Appendix 1
Communication and Correspondence

**RE: TOWN OF COLLINGWOOD EXISTING CONDITIONS MODELLING
 PROJECT INITIATION MEETING**

DRAFT REPORT

Figure 3-3 Study Watersheds

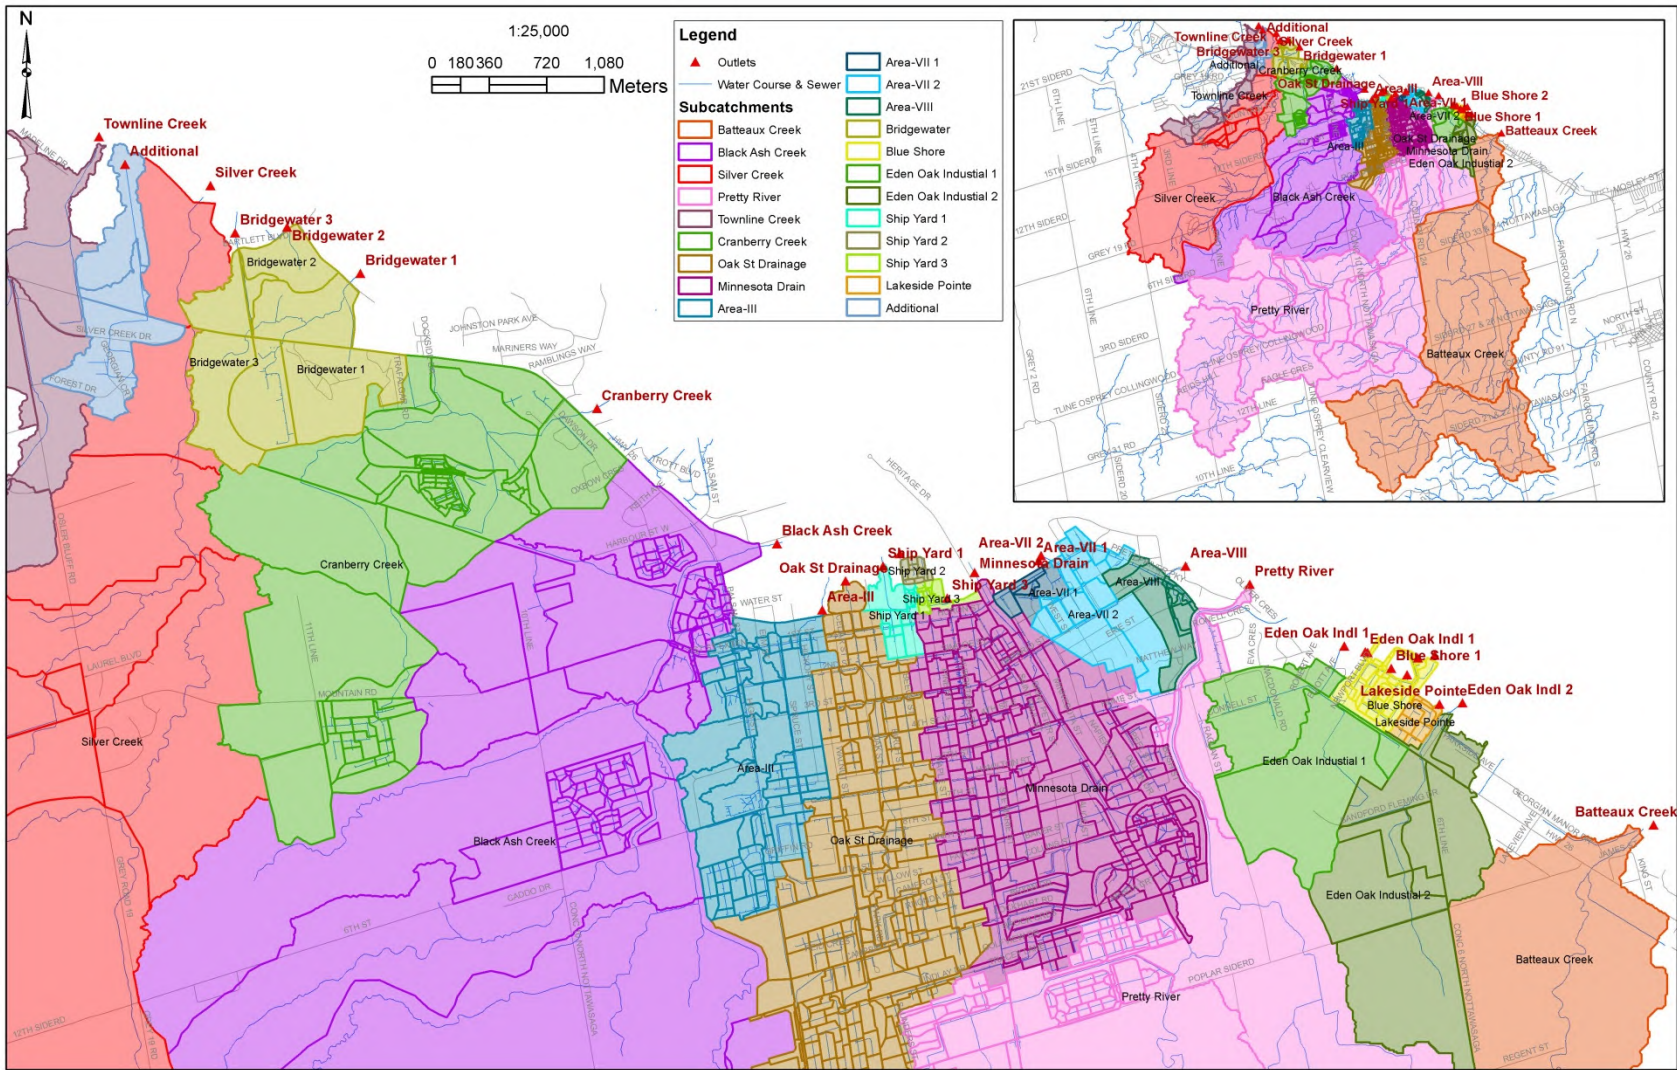
6	6	Deletion "the"	
7	7	Deletion "updated"	
8	11	Do these catchments represent all outlets within Collingwood? There are more outlets to the lake than identified in this drawing. For example, there is an outlet down Elliot Ave that drains the industrial properties along Hwy 26 East (AG Global/Starch plant all the way to Pilkington). Have areas east of the Batteaux Creek been analyzed? Please include an overall map that shows individual catchments per outlet?	The figure was updated to include additional minor outlets. The areas east of Batteaux Creek were not analysed, the storm sewers are not available for these areas. Figure 3-3 now also shows individual catchments per outlet.
9	11	Summit View drains to Black Ash Creek	It drains to Black Ash Creek in the model.
10	11	Where did these naming conventions come from?	From the report: Functional Servicing and Stormwater Management Report - Bridgewater on Georgian Bay (C.F. Crozier & Associates Inc. 2018)

Comment 8: updated figure

Figure 4-3 Pretty River Watershed in PCSWMM

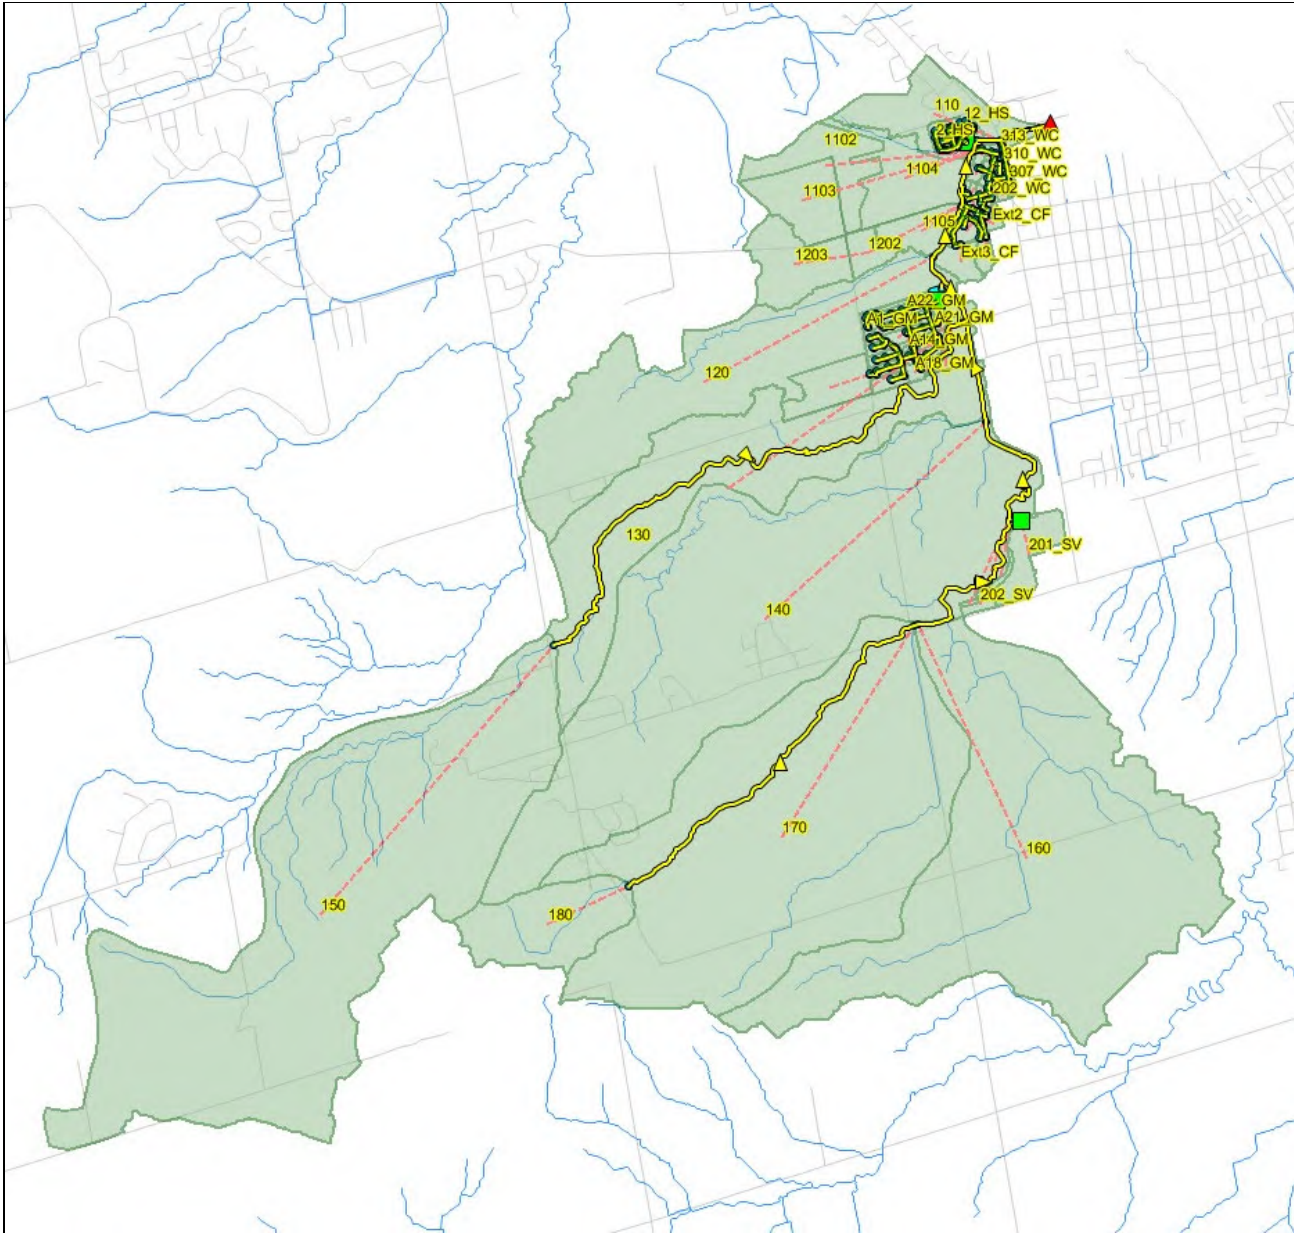
Comment 13: updated figures for BAC and Pretty River

Figure A2- 4 Installed Flow Monitor Locations

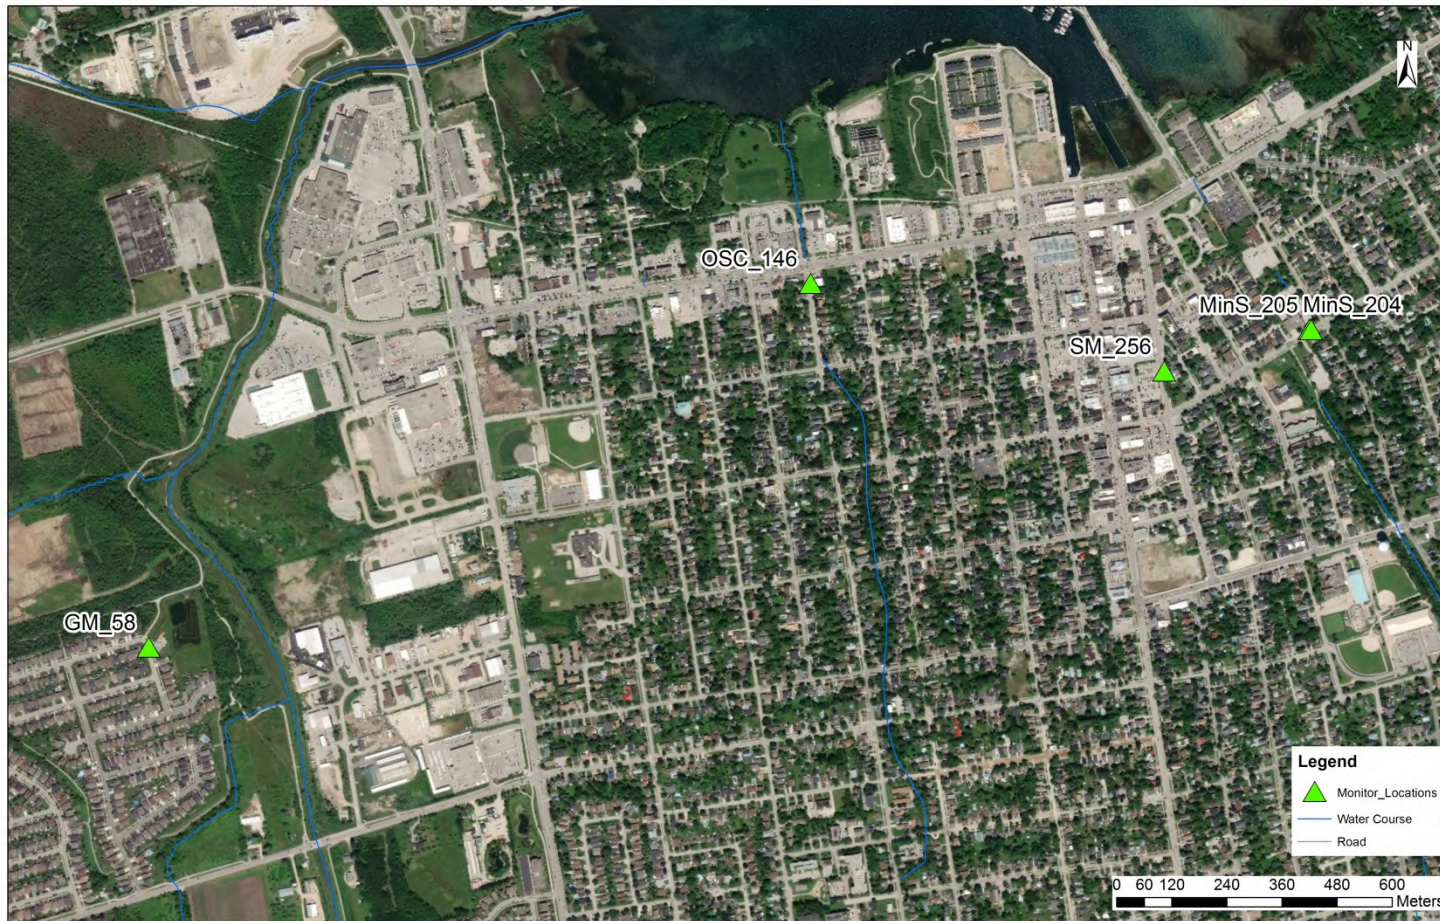
Comment Number	Page Number*	Comment	Greenland Response
4	12	Map should be updated	Map has been updated.
5	17	This is very concerning as summer events are very localized. Why wasn't a rain gauge installed? This is something Calder should have been able to do.	These were only small events. We have subsequently adjusted our calibration with several storm events in 2020.
6	35	Provide QA/QC report. LIDAR provider included text files showing the deviation between LIDAR and known surveyed points. This should be included in the appendix to confirm accuracy. NVCA will want this.	The documentation has been provided in the Pretty River report in an appendix that has been included with the package to the NVCA.
7	49	The explanation of these two scenarios should be moved from Section 7, to somewhere before this section.	The section was moved to another location.
8	50	References are not correct. All should be checked.	These were adjusted as required.

Comment 4:

Sewer north of Second St.

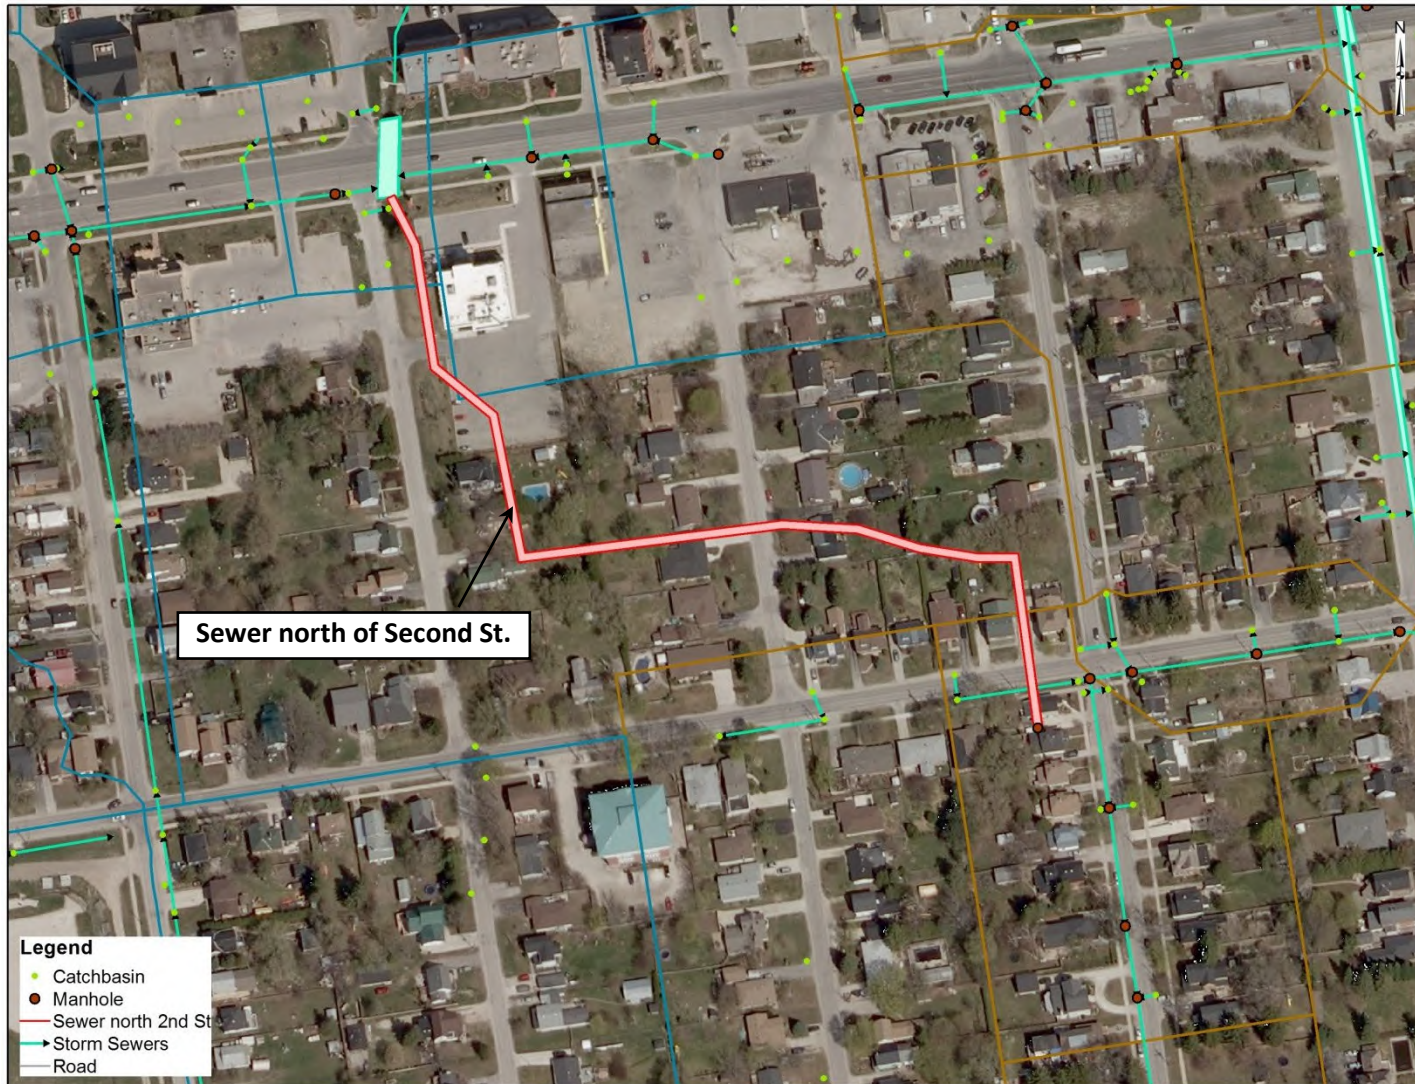
Comment 17: The pipe north of Second St missing upstream manholes and catch basins. The drainage area is based on the pipe location. Due to lack of upstream catch basin and manhole connections, the catchment runoff is connected to the downstream end manhole. At upstream end, the catch basins connected to other pipes. Need more information for inflow condition.
